# UNITED STATES PATENT AND TRADEMARK OFFICE

Application Number: 10/051,577  
Filing Date: January 16, 2002  
Appellant(s): RATHERT, HORST

EXAMINER'S ANSWER

Problem B – As seen in figure 2;

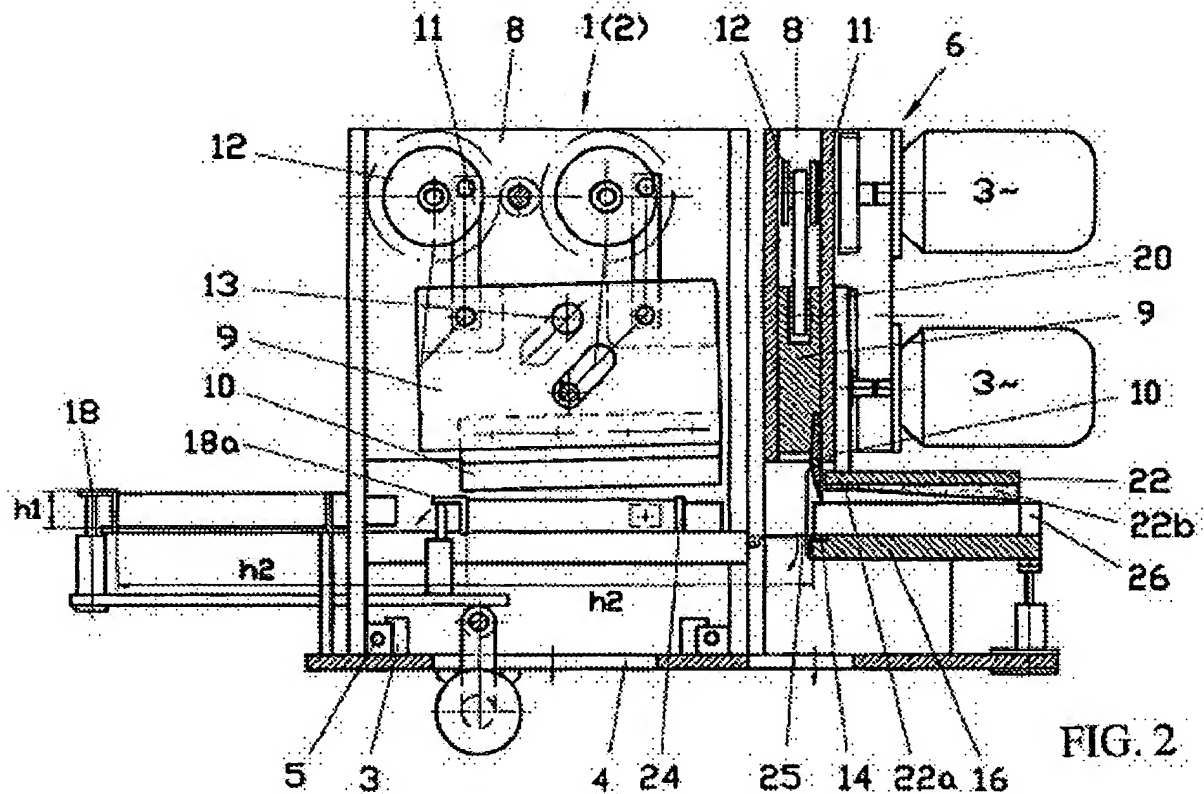
Each cutting unit has three motors; two on top to drive the blade and one on bottom to drive the clamp. The two motors on top drive eccentrically mounted links (11) that would create a wobbling reactionary force that would be transmitted to the support frame. The bottom motor drives a laterally offset rack (20), which would create a reactionary torque that would be transmitted to the support frame. The blade (9) moves diagonally and the rack (20) moves vertically and would create reactionary diagonal and vertical forces that would be transmitted to the support frame. The blades and clamps impact the workpiece in a downward direction, which is a force that would be

transmitted to the support frame. So there are at least 6 unique forces that are “dynamic forces” or “pressing and cutting forces” that are transmitted to the support frame, which begs the question of “how are the cutting units *closed in themselves*”.

One of ordinary skill could arguably be aware of ways to minimize simple reactionary forces by employing counterbalances of some sort (e.g. a “recoilless rifle”). But in this case, there are so many forces working in so many directions that it is not at all clear how one would avoid transmitting forces to the support frame, even assuming one could solve problem A first and know which forces had to be stopped. Even if the forces in question are just the impact of the blade and pressing strip onto the book, then it is still not obvious how to not pass those forces on to the support frame below. This is an especially tricky problem because different books being trimmed have different thicknesses, and thus the knife and clamp will impact at different times depending on the book thickness, and thus and knife-and-clamp-impact force compensator would have to have some complex mechanism to take this into account in order to substantially counterbalance the downward force for different book thicknesses.
